NRC Request for Information

# Atlas Corporation Reclamation Plan Uranium Mill and Tailings Disposal Area

PARTIAL RESPONSE TO NUCLEAR REGULATORY COMMISSION  
REQUEST FOR INFORMATION  
ENCLOSURE 2 - OTHER CONSIDERATIONS  
RECLAMATION PLAN  
URANIUM MILL TAILINGS SITE  
MOAB, UTAH

DRAWING NUMBER 88-067-E66

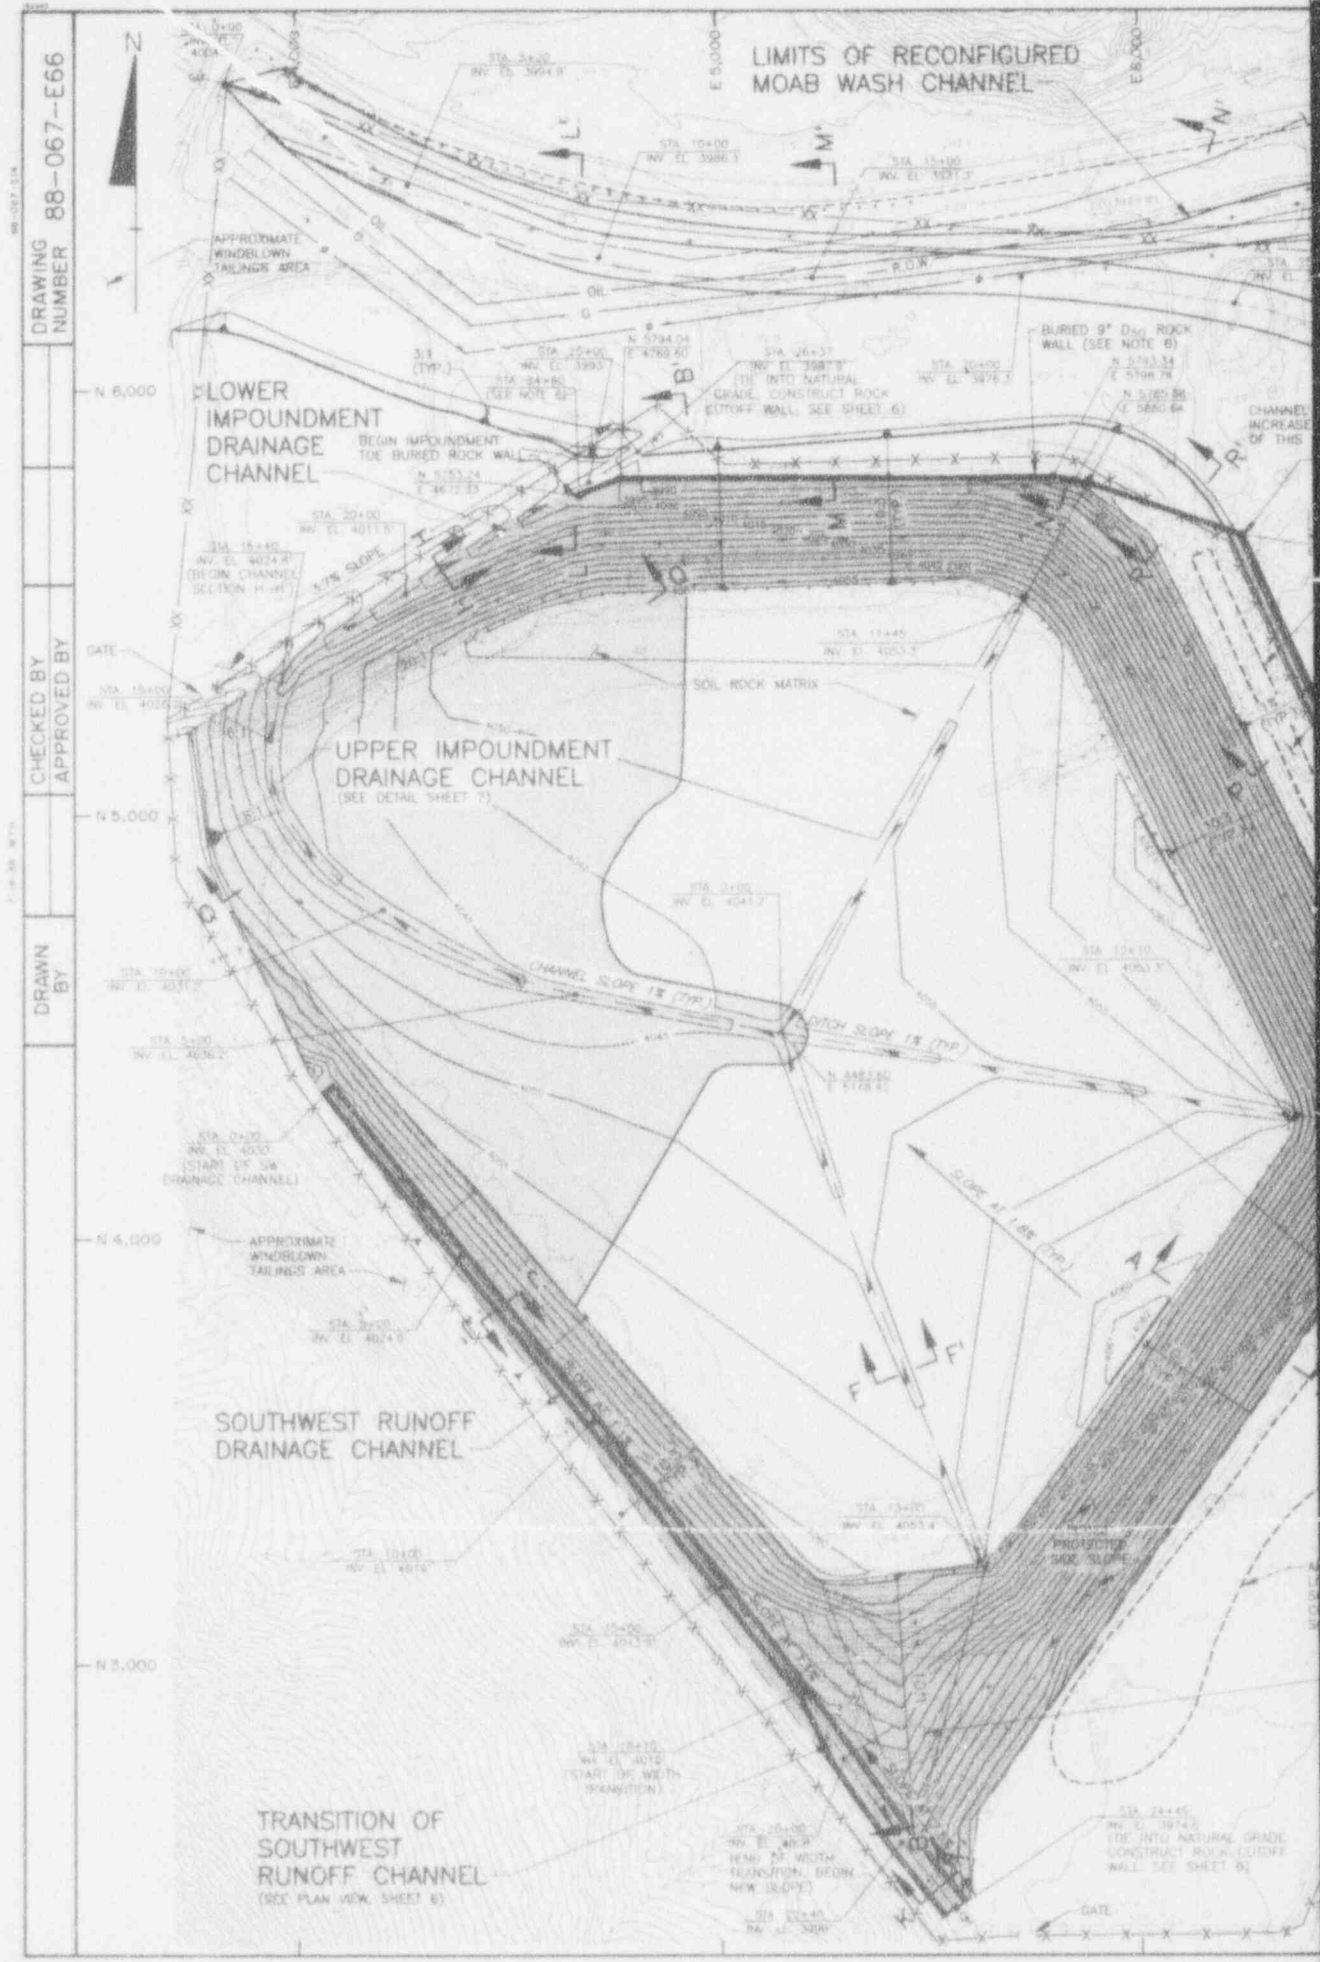
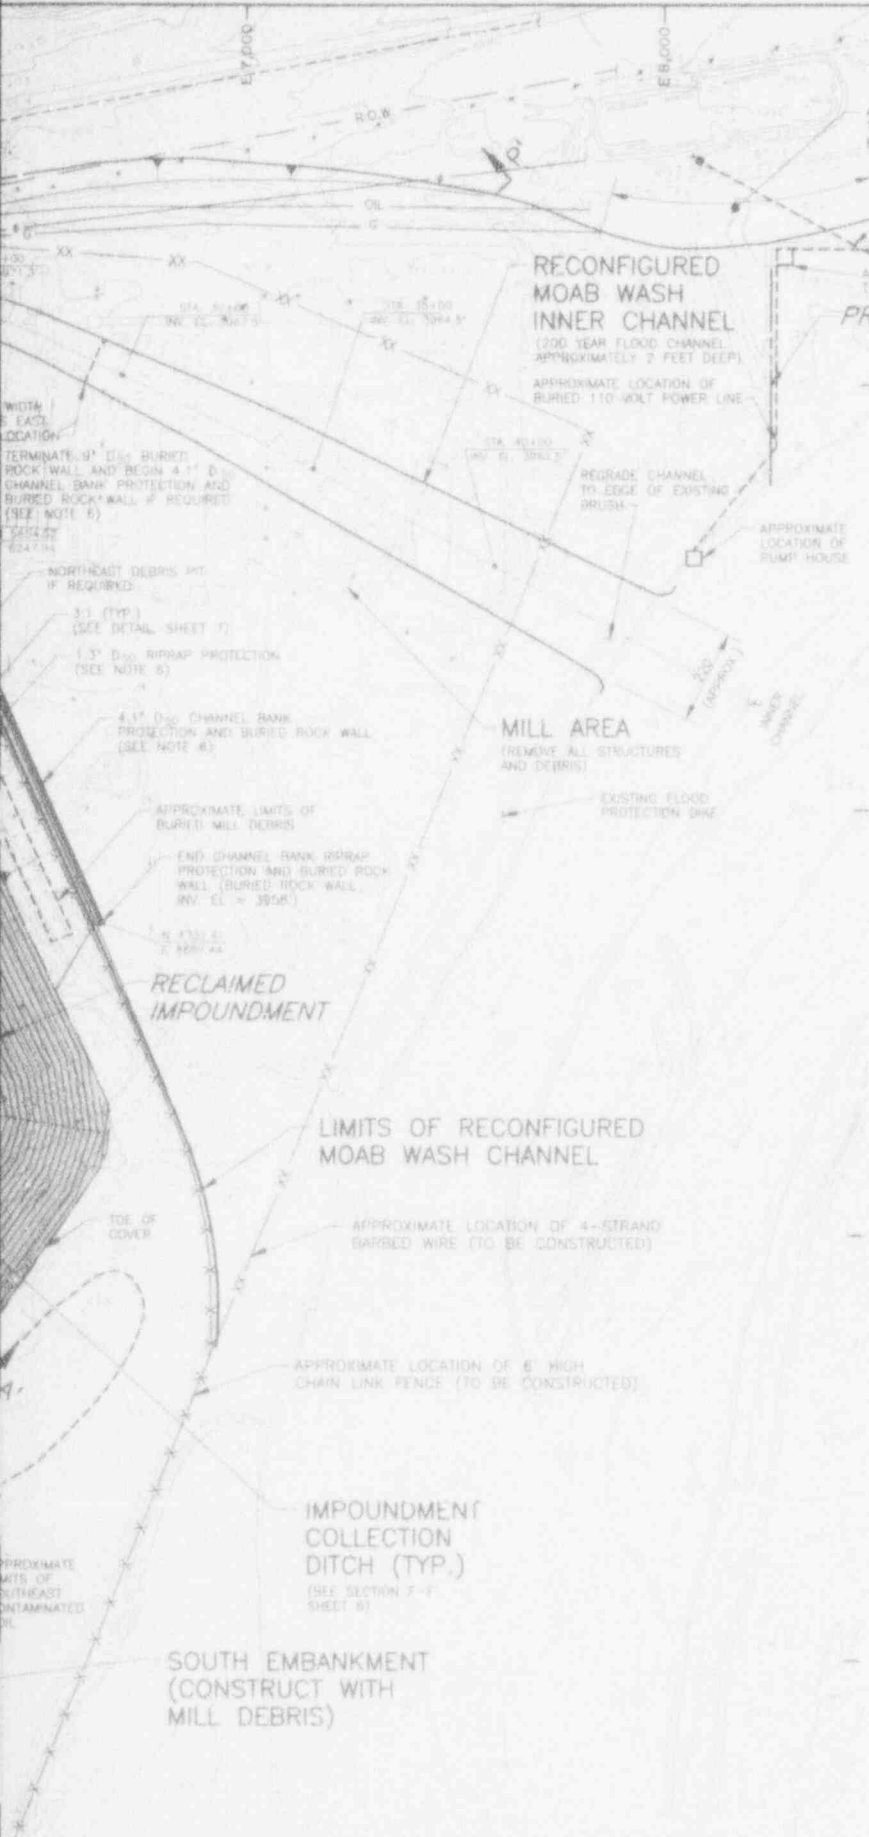
2. Along with the question on the effect of floods in Moab Wash on the tailings pile, previously transmitted by our letter of April 20, 1993, it appears that the erosion protection for the Lower Impoundment Drainage Channel could also be affected by Moab Wash. If Moab Wash were to

migrate and/or erode a channel near the proposed outlet of this channel, the erosion protection design proposed for the channel may not be adequate to accommodate the flow velocities and shear forces in Moab Wash. Therefore, you should substantiate that the erosion protection is adequate to resist the velocities in Moab Wash, or revise the design accordingly, and submit for our review and approval.

With respect to Moab Wash in the vicinity of the Lower Impoundment Drainage Channel and to the east [sections L-L', M-M' and N-N' on Drawing No. 88-067-E66 (Sheet 4 of 10)], design calculations submitted in Appendix B of this document indicate that 9-inch D50 rock wall is required to protect the embankment from encroachment by Moab Wash. The 9-inch rock wall at Sections L-L', M-M' and N-N' were designed to withstand a velocity of 11.7 fps, local boundary shear of 2.4 psf and depth of scour of 6.7 feet. The riprap for Moab Wash and the rock cutoff wall at the outlet of the Lower Impoundment Drainage Channel was sized based on the PMF event in Moab Wash using the U.S. Army Corps of Engineers (allowable local shear stress) method. Toe protection for the channel bank protection and scour depth were considered in the calculations. Based on this analysis, erosion protection is adequate to resist the velocities in Moab Wash.
